multiDISPLAY 1st generation

multiDISPLAY 2nd generation

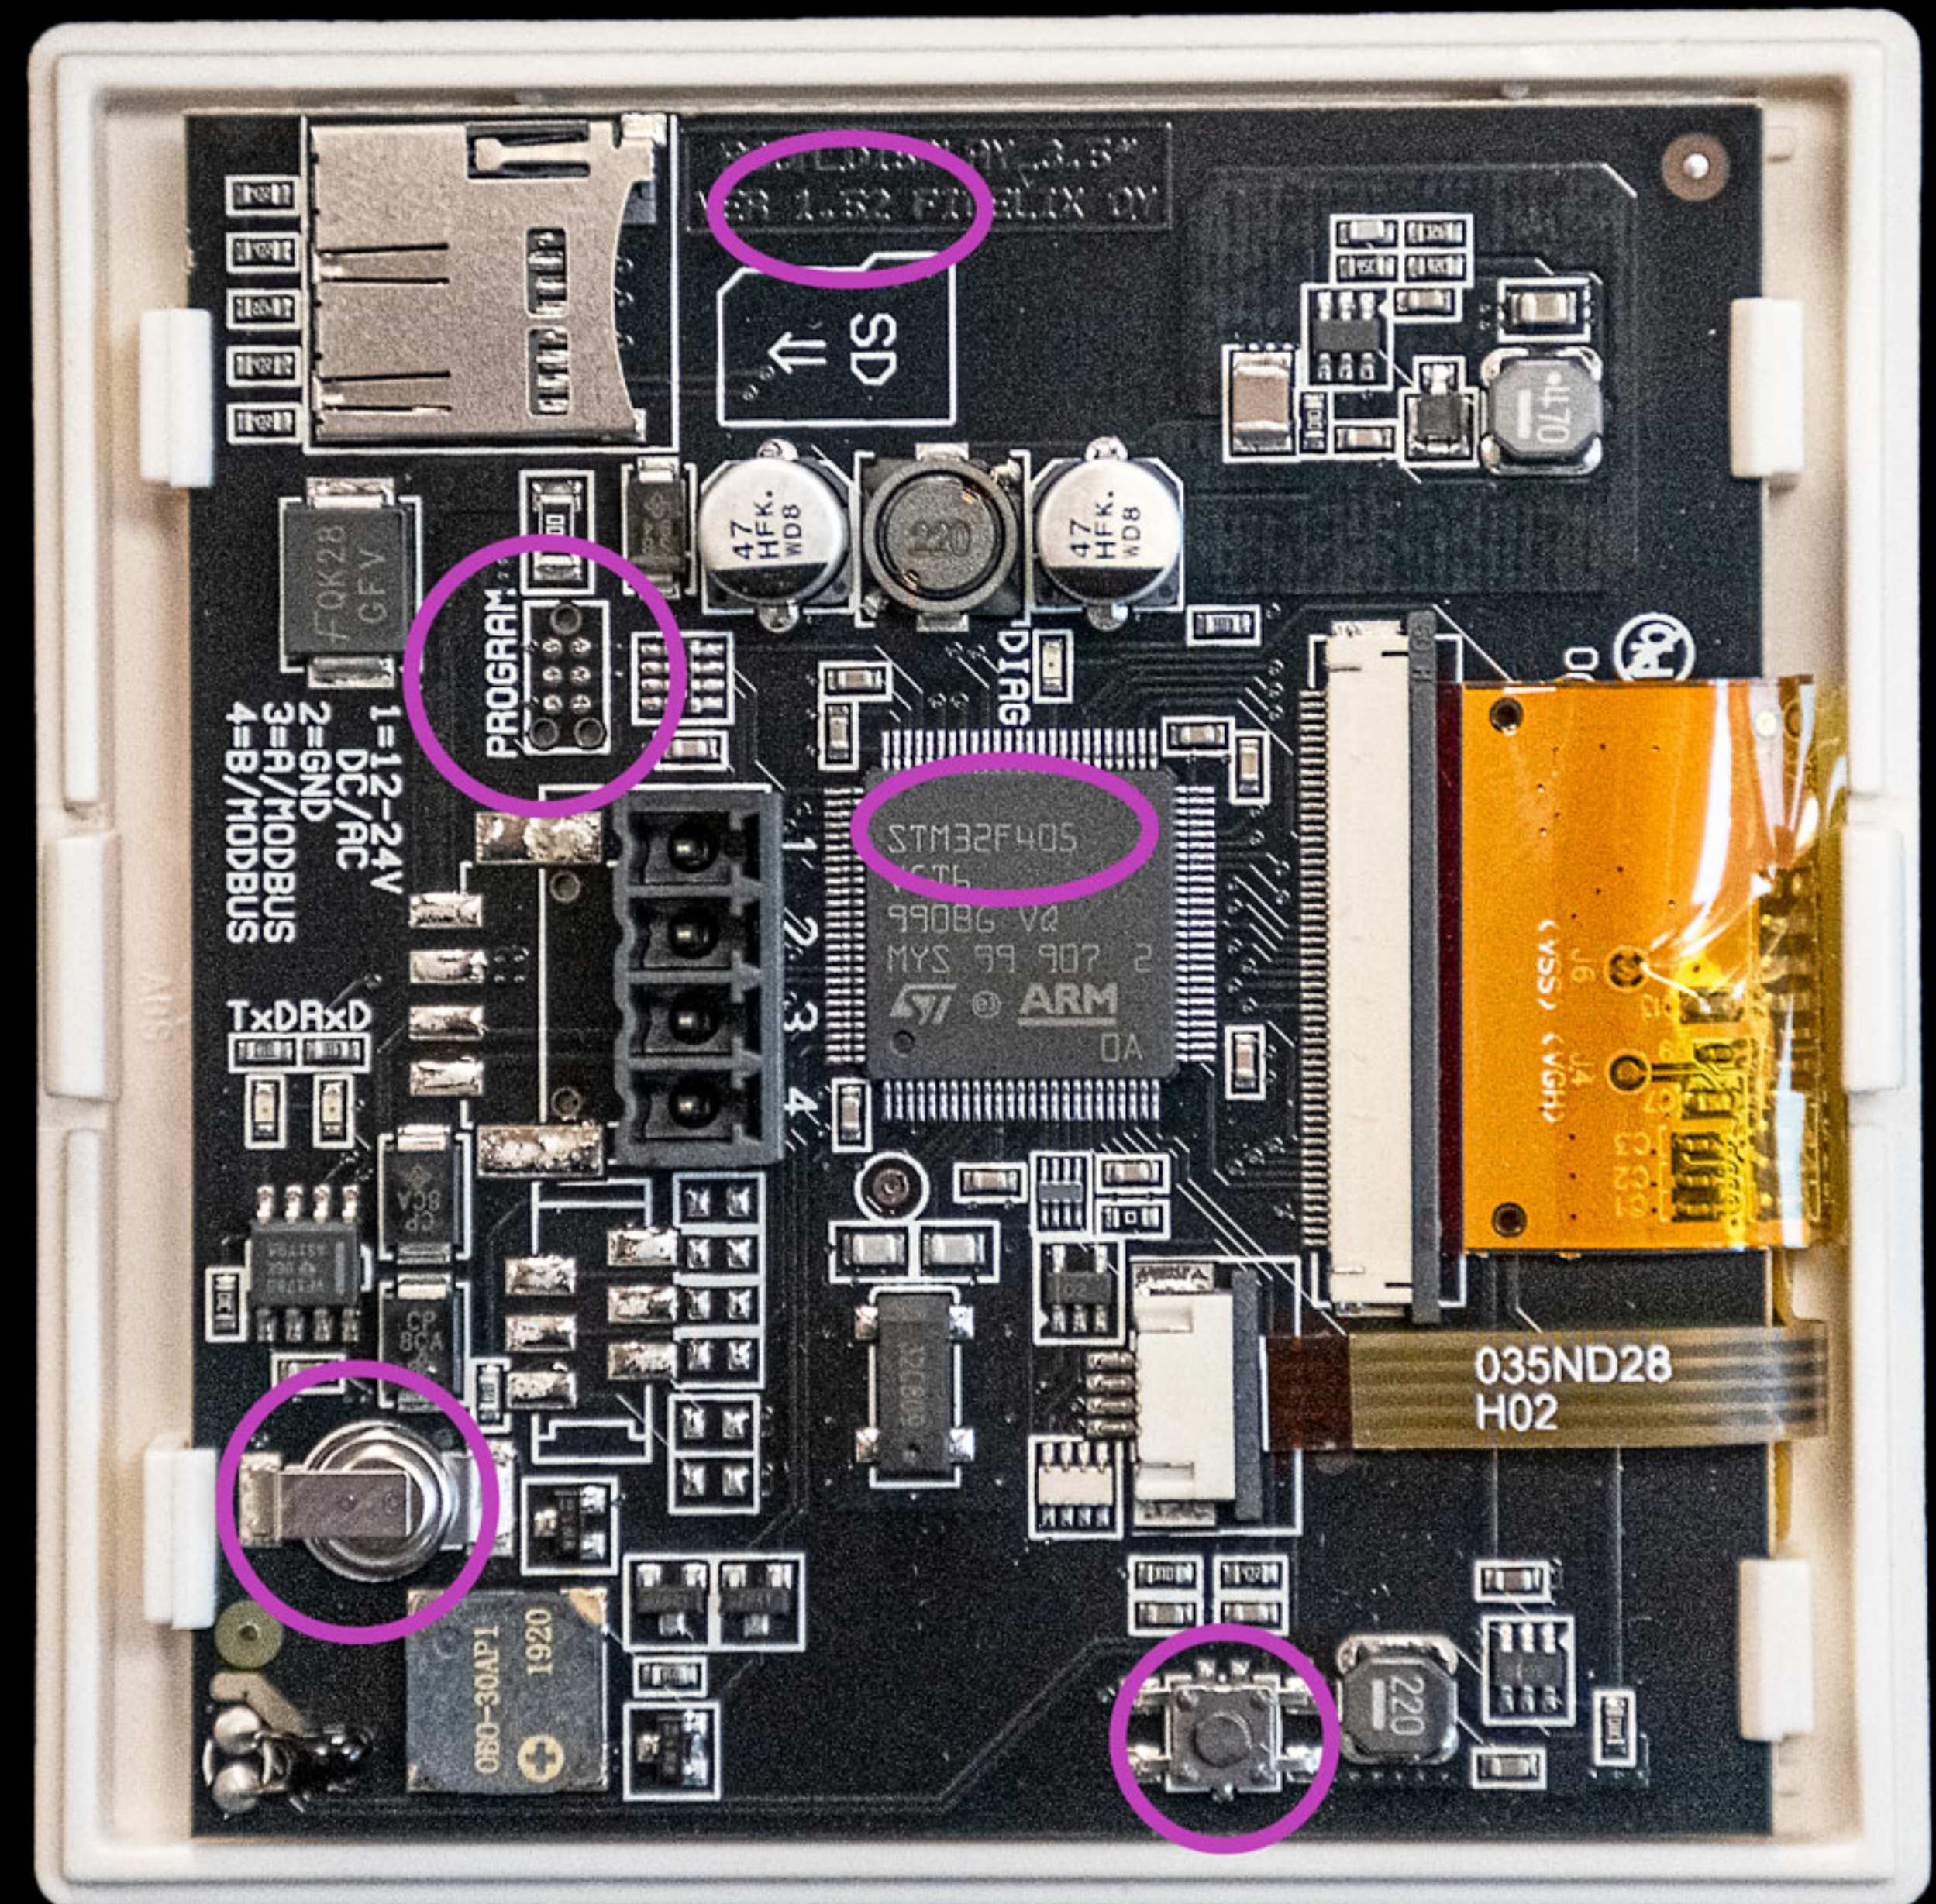
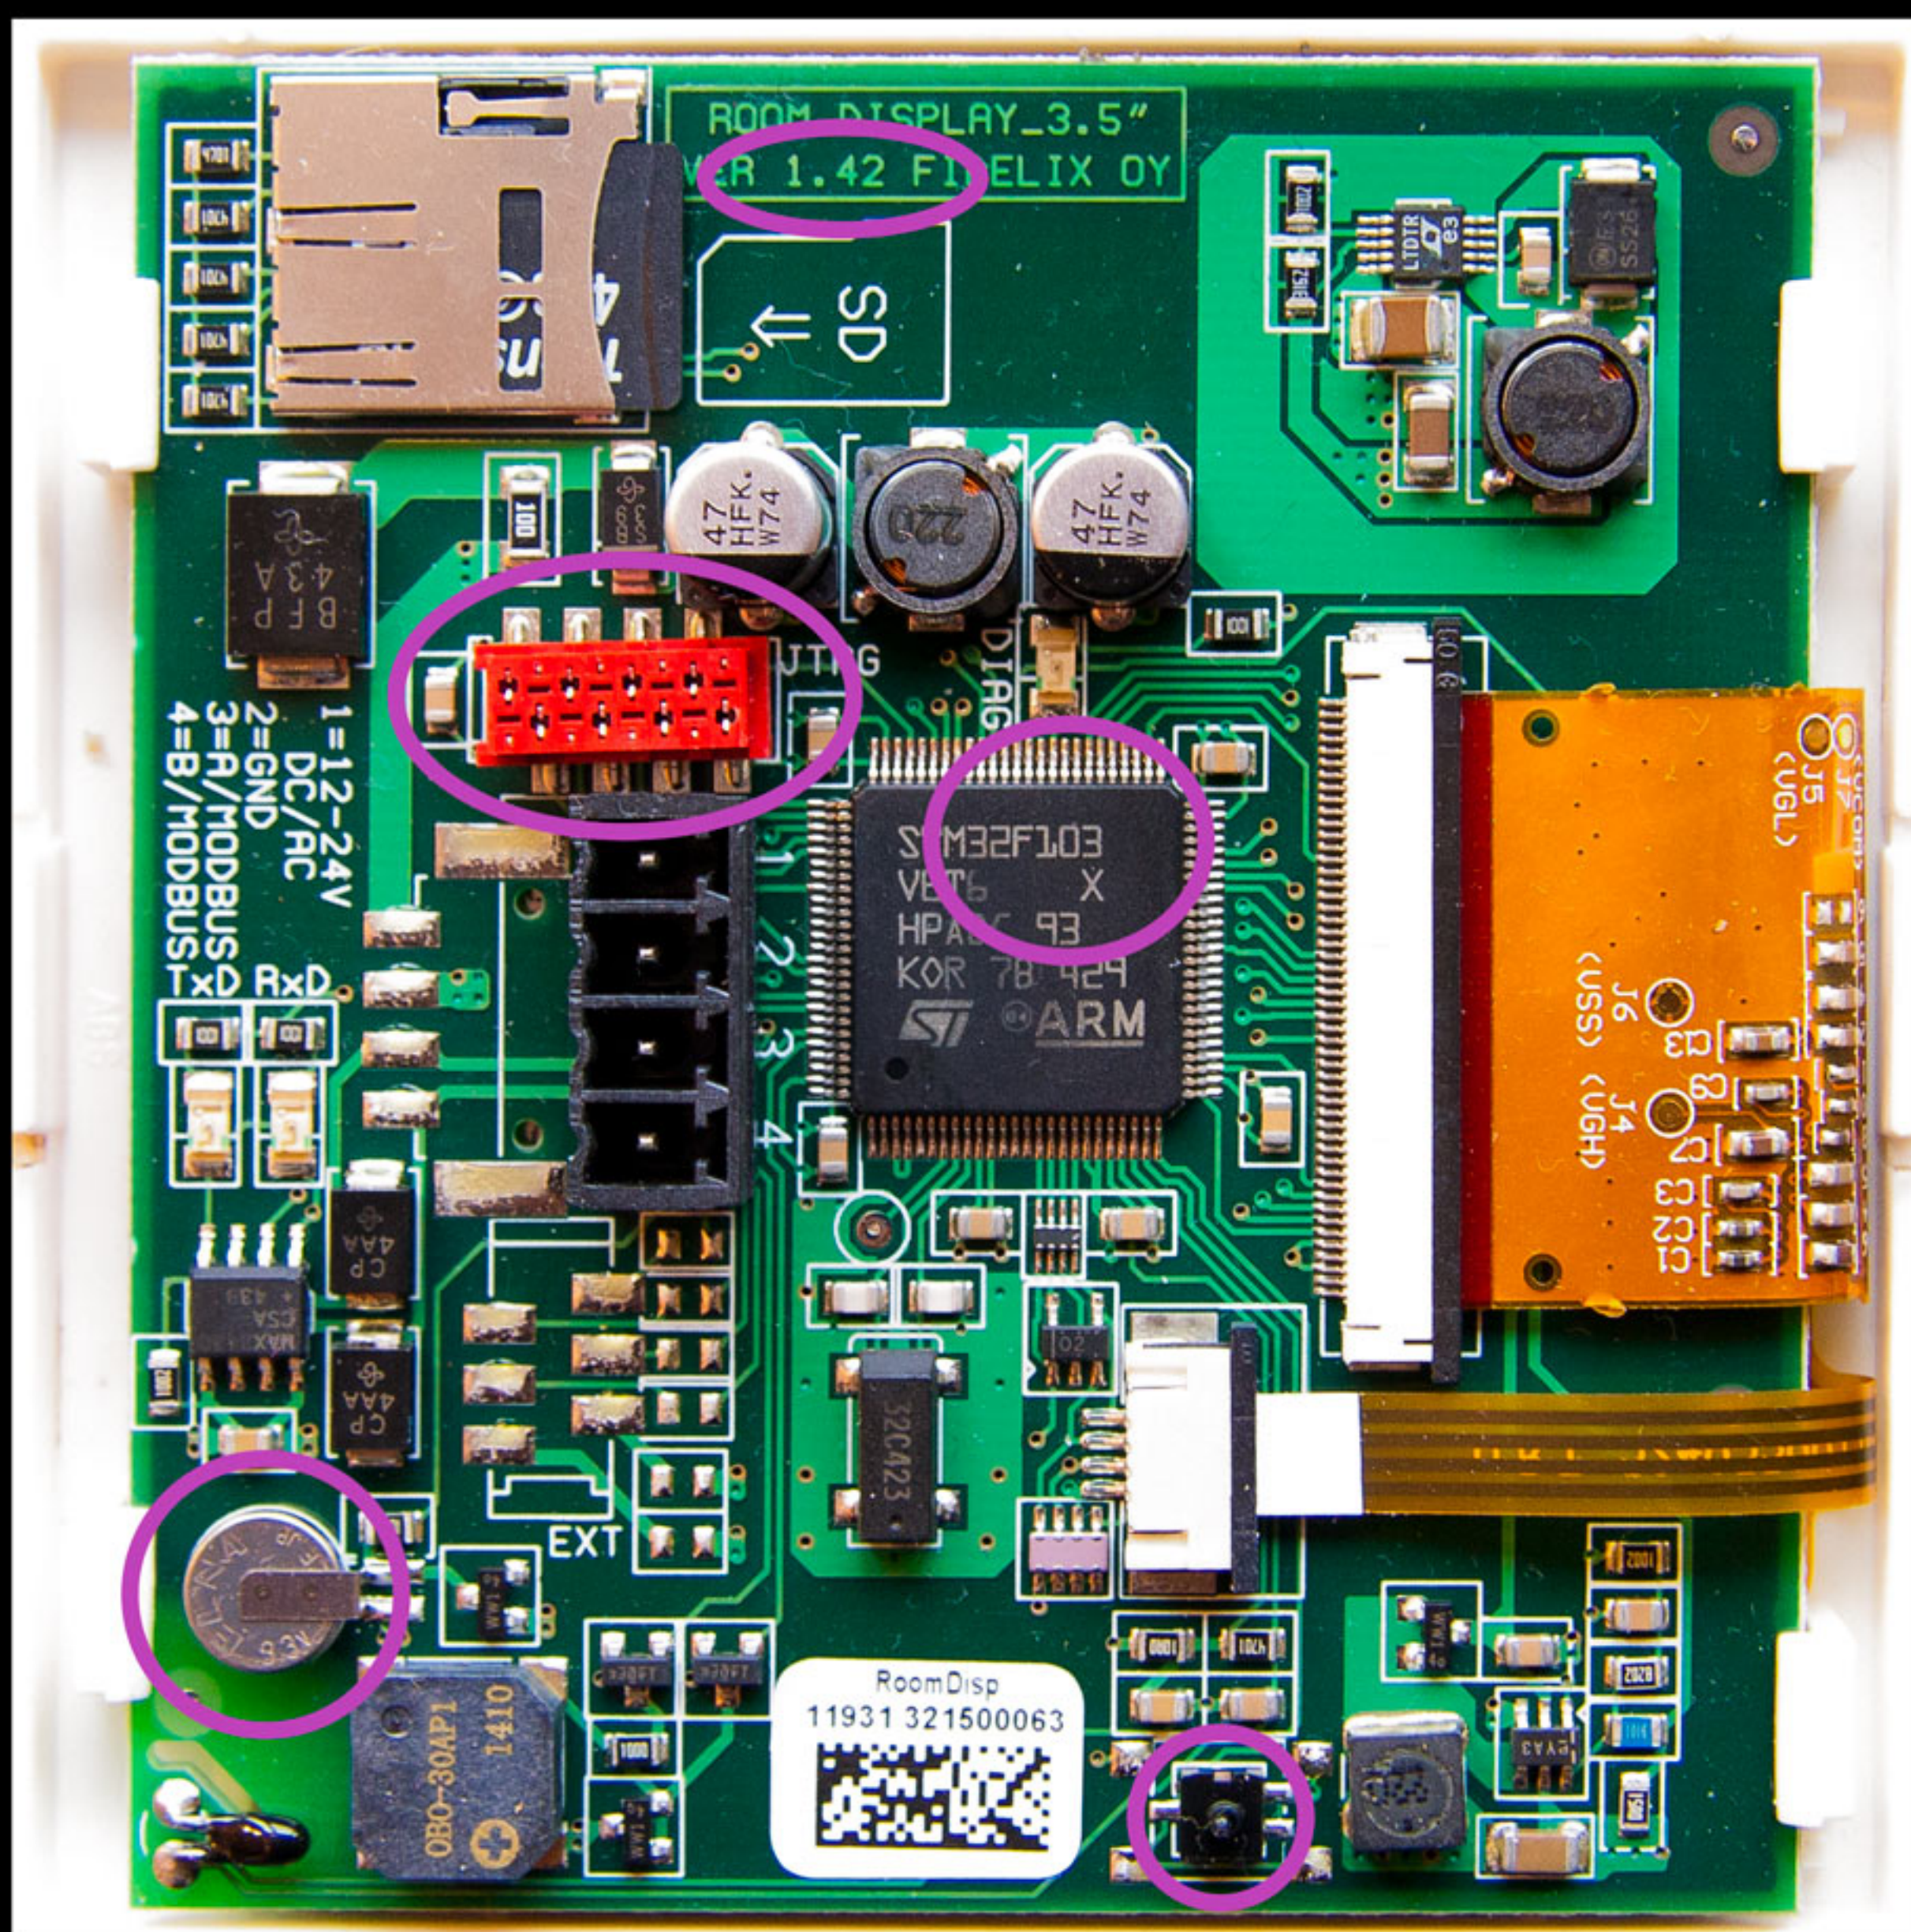
Changed components

- different capacitor and holder
- different programming connector for production
- different tamper switch
